SINGLE SIDEBAND
RADIO COMMUNICATIONS EQUIPMENT

TYPE - SSB-1

ADDENDUM No. 2.

TEMPORARY CORRECTION T-1 TO THE TECHNICAL MANUAL FOR TYPE SSB-1 SINGLE-SIDEBAND RADIO COMMUNICATION EQUIPMENT (NAVSHIPS 92917).

Figure 29- C Transmitter-Receiver Schematic (Serial Numbers 5701 and above).

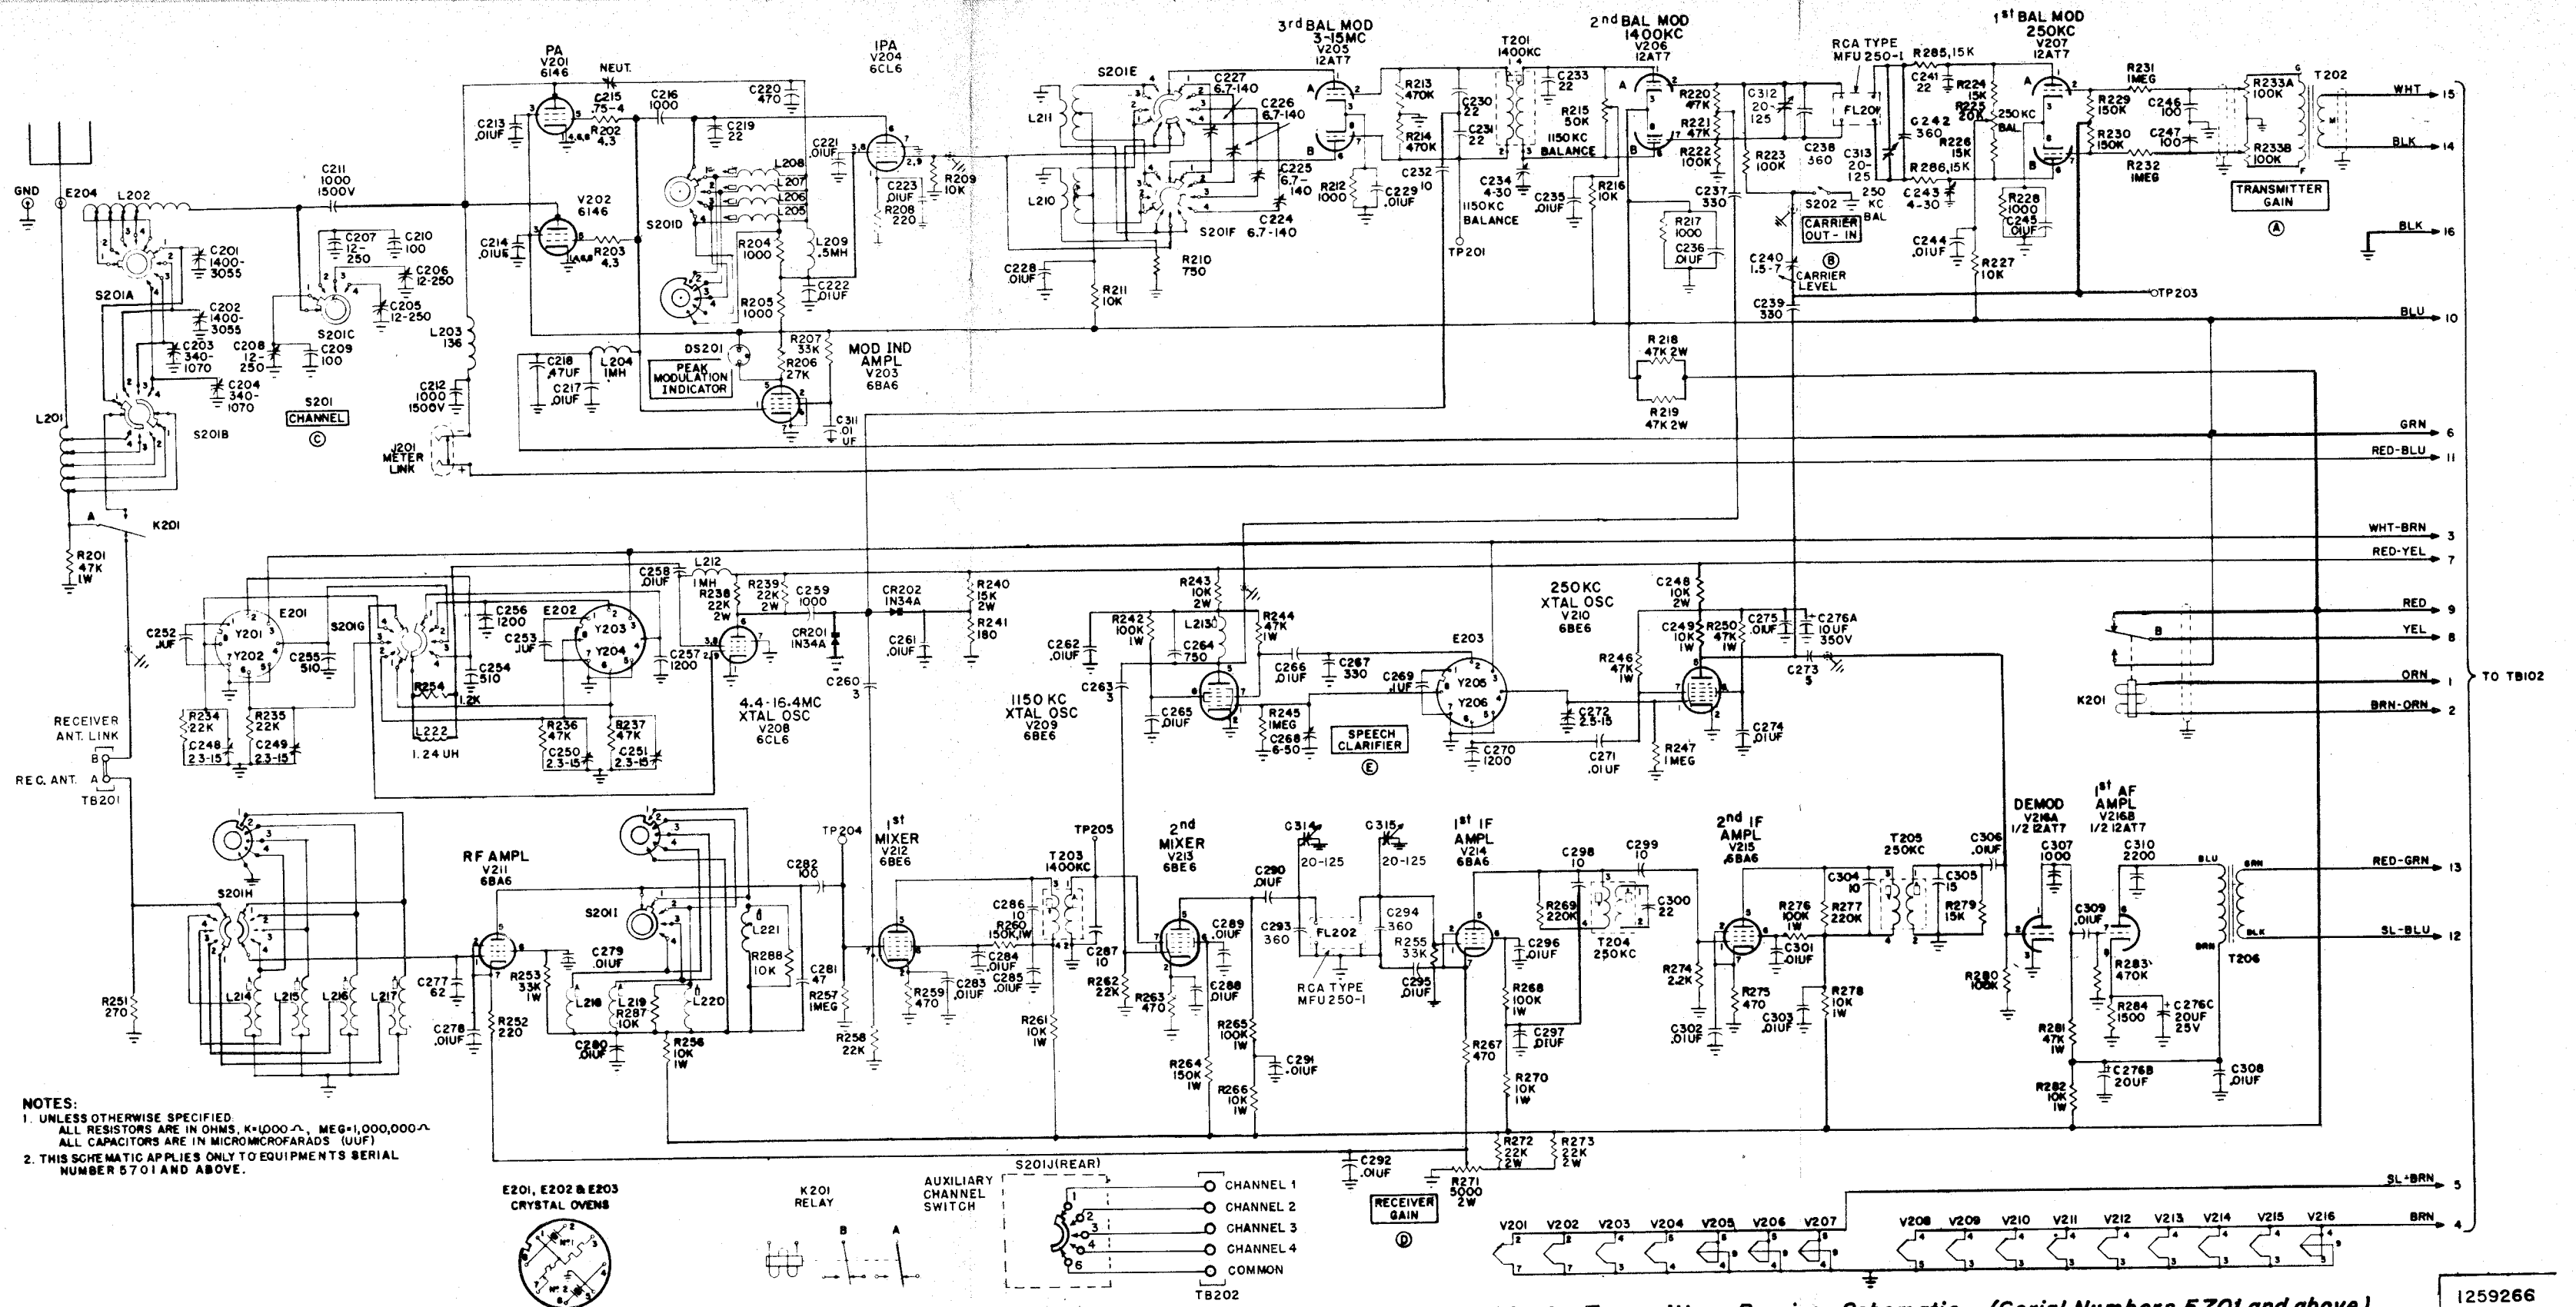
1. Add shorting sections to Switch Wafers S201, D, H, and I.
2. Add Auxiliary Channel Switch wafer S201-J.
3. Add Auxiliary Channel Switch Terminal Board, TB202.
4. Add Receiver Antenna Link, TB201.
5. Add R287 and R288.

Item 1. The shorting sections of the switch wafers S201-D, H, and I, remove the unused coils from the radio frequency circuits of the transmitter and receiver, thus reducing losses and improving efficiency.

Item 2. The Auxiliary Channel switch wafer, S201-J is an extension of the channel Selector Switch. The five contacts of this wafer are brought out to a terminal board (TB202). One contact is common to all the other contacts so that a AC or DC current may be applied in series with a control device such as a relay indicator lamp, etc.

Item 3. The Auxiliary Channel Switch Terminal Board (TB202) provides a terminal connection for the Auxiliary Channel switch and any outer contacts required for control operation of auxiliary equipment.

Item 4. The Antenna Link on TB201 is removed when a pre-amplifier for the receiver or a linear power amplifier to follow the transmitter power amplifier is required. The input and output terminals of such amplifiers are connected to terminals B and A.

Item 5. The resistors R287 and R288 connected across L220 and L221 respectively provide greater receiver stability for channels 1 and 2 thus improving reception on these channels.

Refer to Transmitter Receiver Schematic (Figure 29-C).

Figure 6. Power and Control Circuits

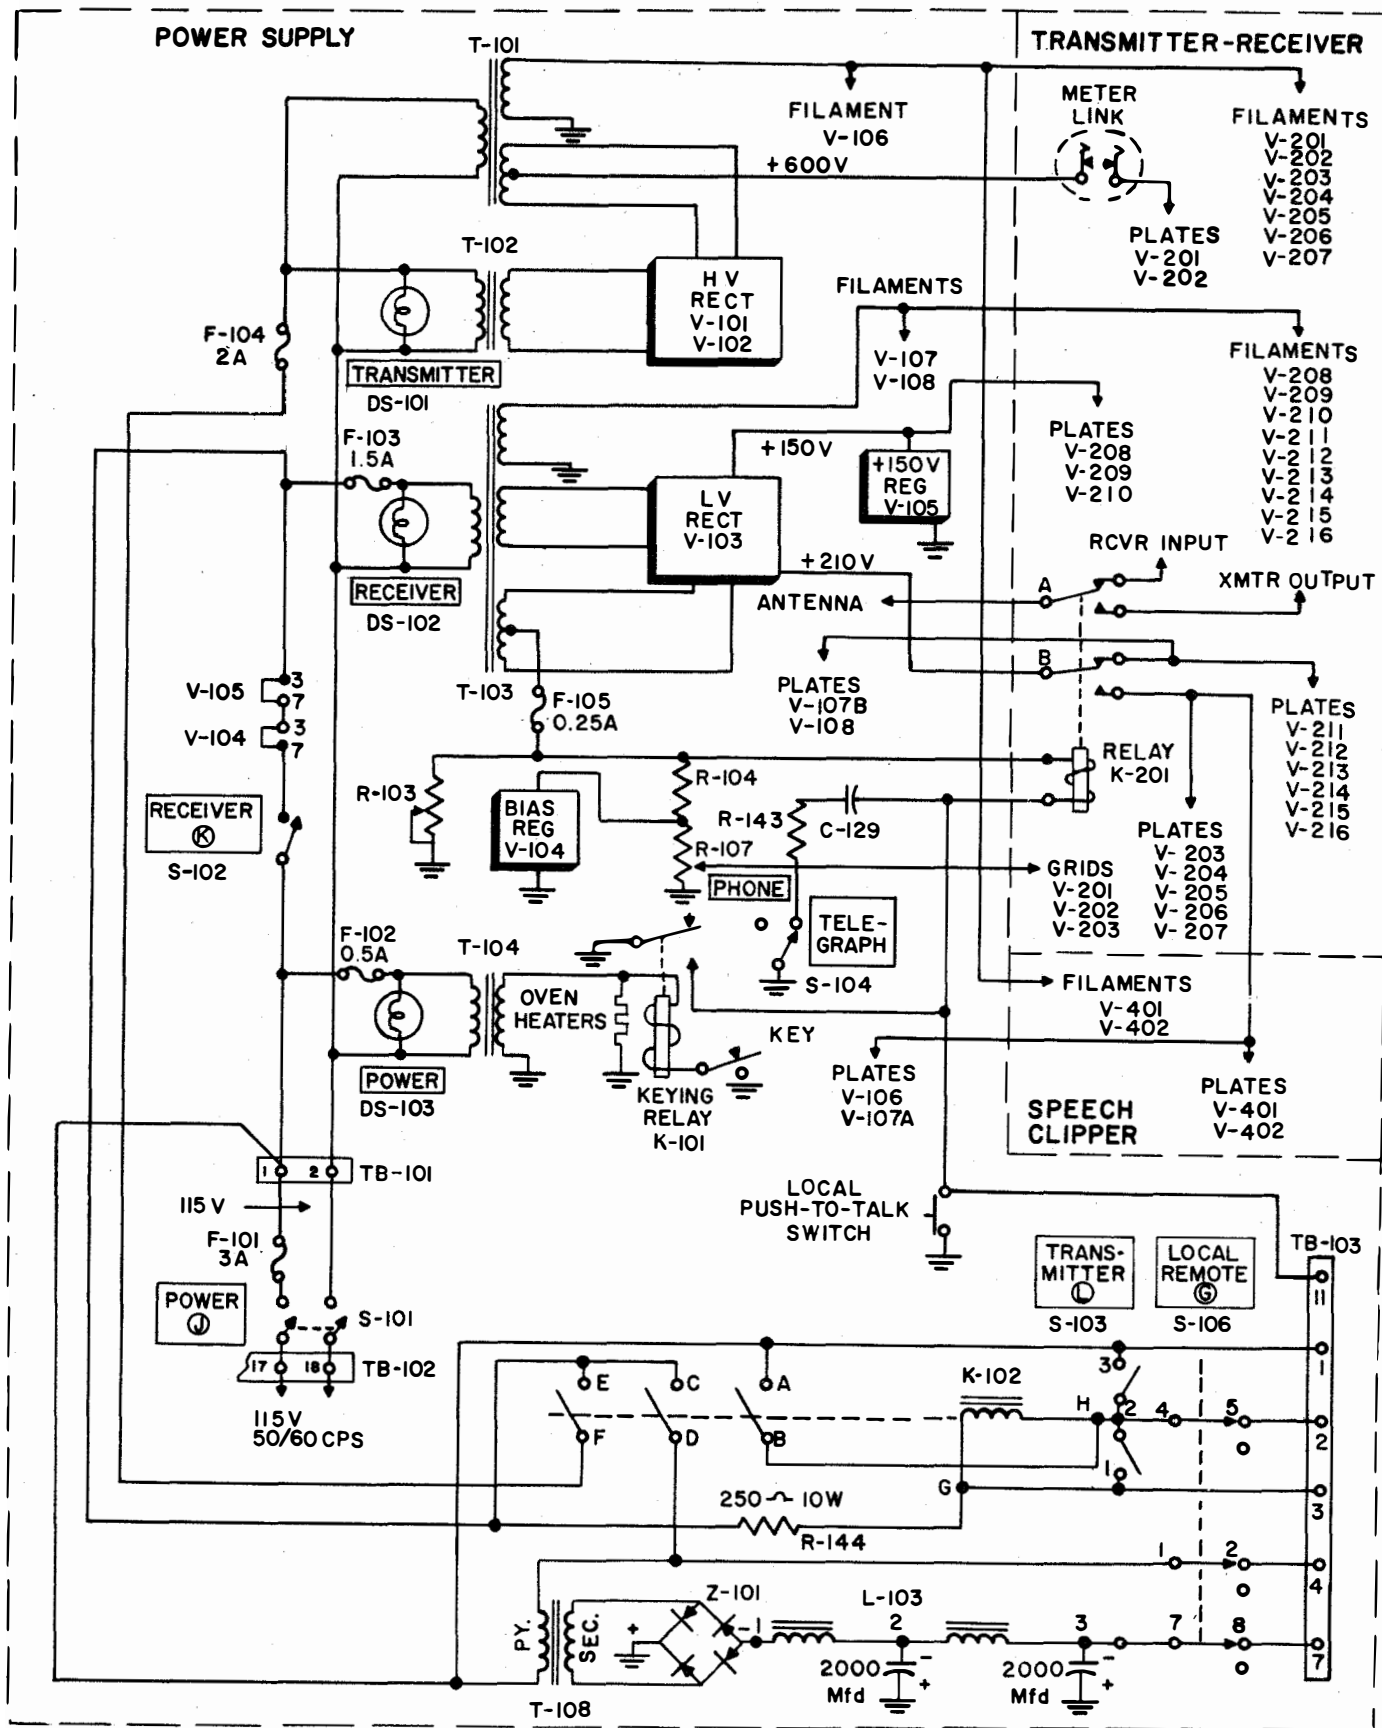
Page	Ref.	Corrections To Be Made
5	LINE VOLTAGE	Delete "230"
5	LAMPS	Change "5" to "2"
7	Figure 3	Paste new Figure 3 over original Figure 3
8	Section I Para. 5	Delete the entire last sub-paragraph.
8	Section I Para. 6	Change the second sub-paragraph to read as follows: The equipment operates from 115 volt, 50 to 60 cycle single phase power source and requires approximately 310 watts for full power output. The equipment is connected to the standard navy remote system by a twelve wire cable for the control circuits, and a two wire audio cable for external speakers.
12	Section II Para. 4.h.	Line 3. Change "T-106" to "T-107"
13	Figure 6	Paste new Figure 6 over original Figure 6.
14	Section II Para. 4. h.	Line 10. Change to read as follows: "operation or remote operation."
14	Section II Para. 5	Change sub-paragraph <u>a.</u> to read as follows: <u>a.</u> Input voltage to the power supply circuit is 115 volts, 50/60 cycle. Refer to figure 6.

MODIFICATION TO TRANSMITTER RECEIVER SCHEMATIC

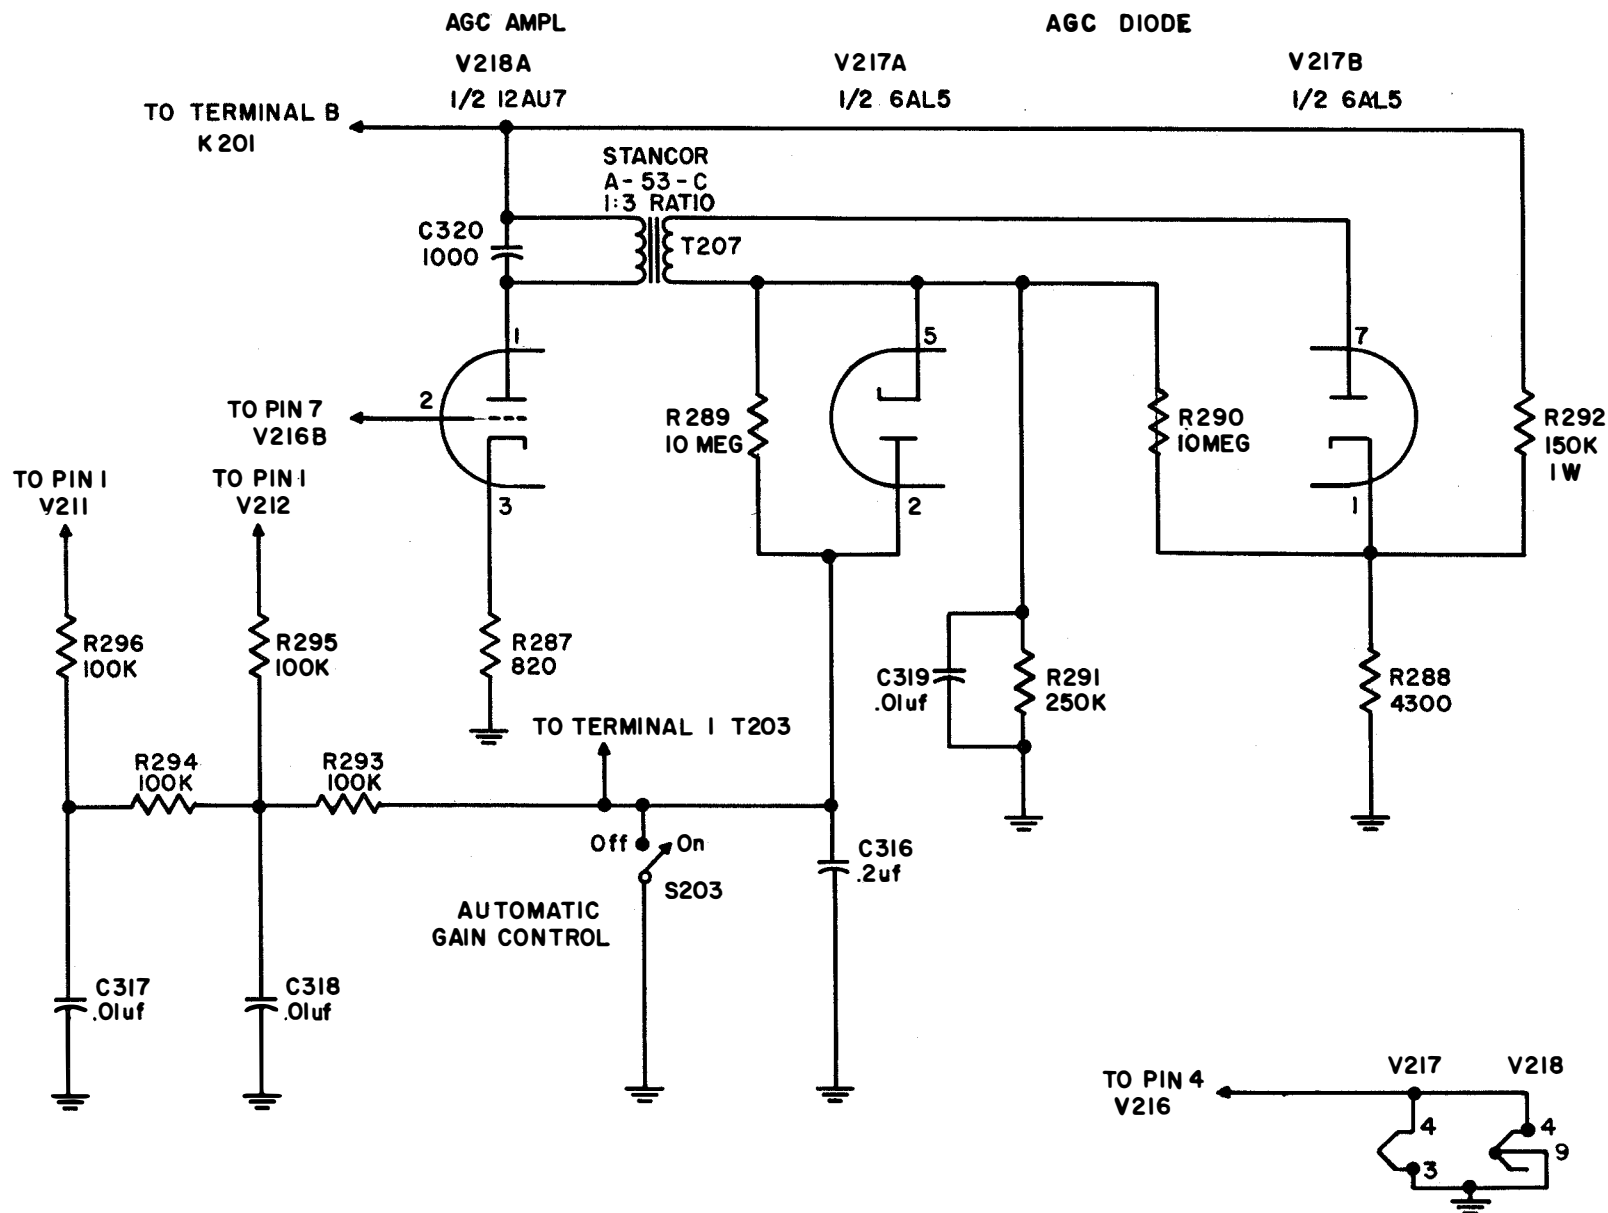
77, 78	Figure 29B	Make the following deletions and additions to Figure 29B: 1. Remove C277, R258, ground lead on terminal 2 of T203, and lead between S201H and pin 1 of V211.

2. Add capacitor C277 .01UF between S201H and pin 1 of V211.

3. Add AGC circuit as shown in MODIFICATION TO TRANSMITTER RECEIVER SCHEMATIC (page 8 of this Temporary Correction).

FIGURE 1

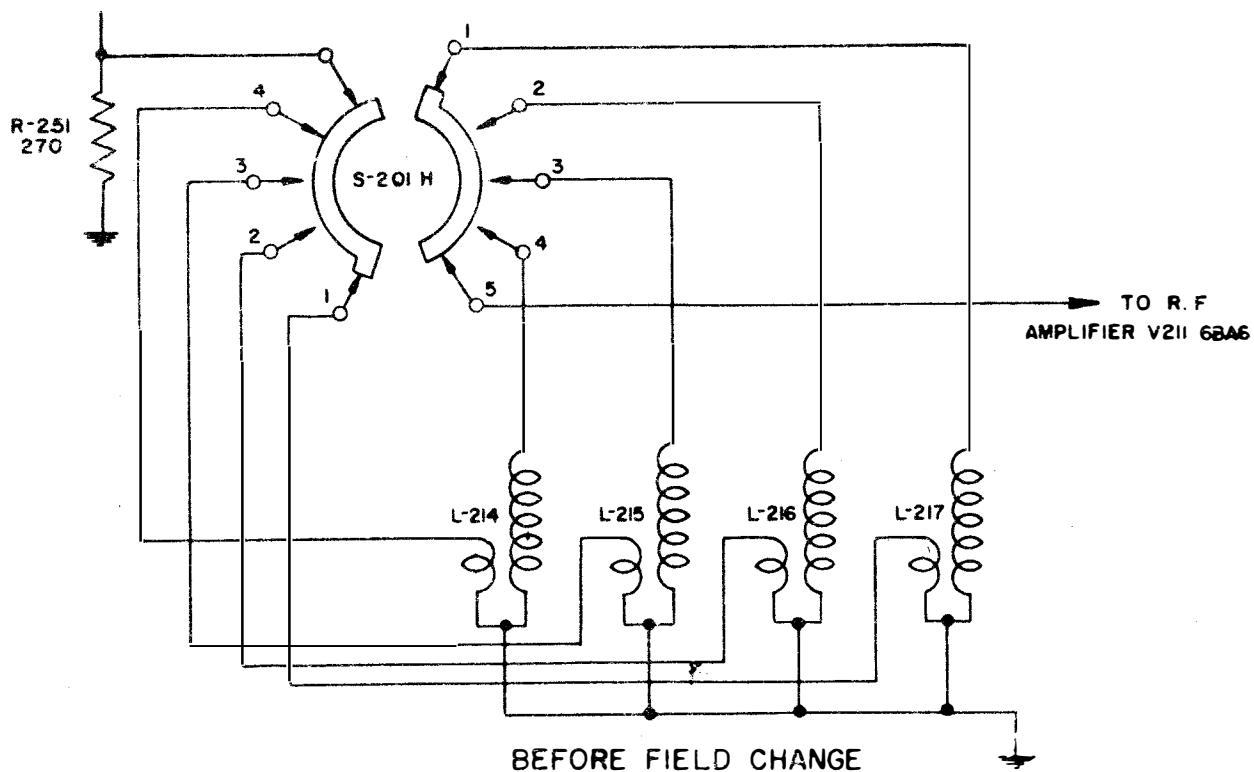
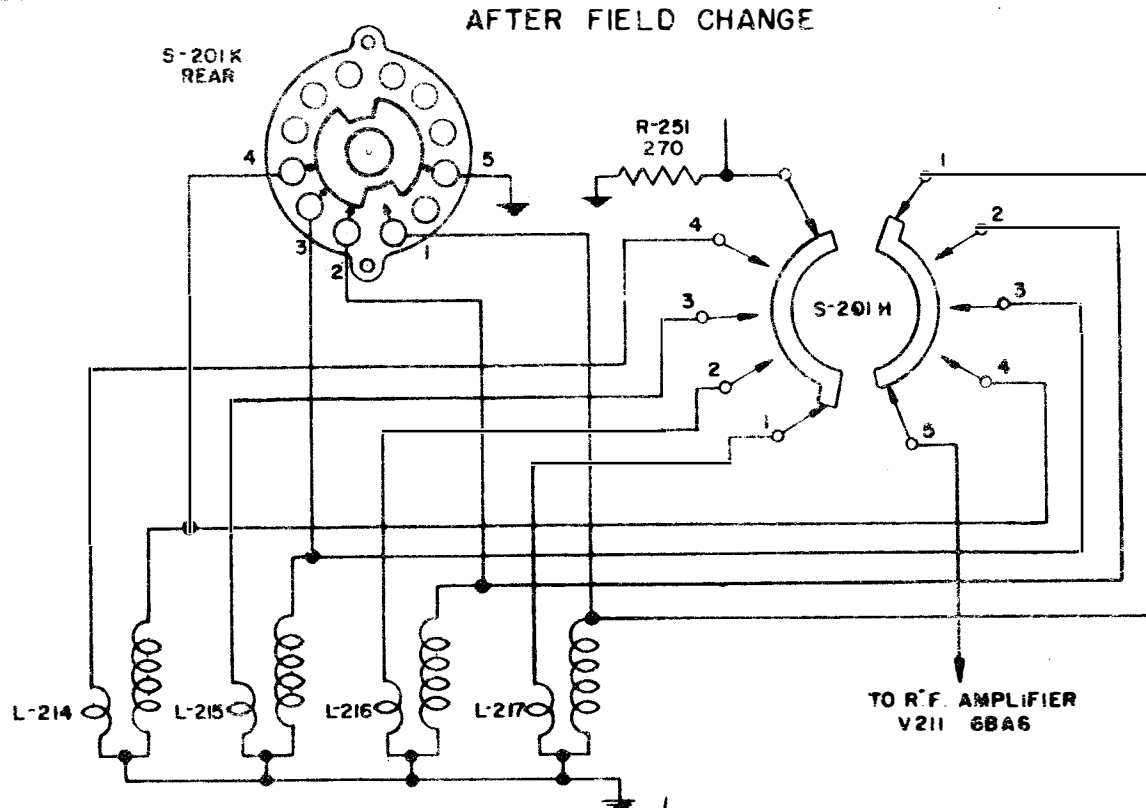
1. Transmitter-Receiver Schematic, Pages 75, 76, 77 and 78; Figures 29 and 29B.

Referring to temporary correction Figures 1 and 2, make the necessary pen-and-ink correction to the Transmitter-Receiver Schematics to conform with Field Change 6-SSB-1.
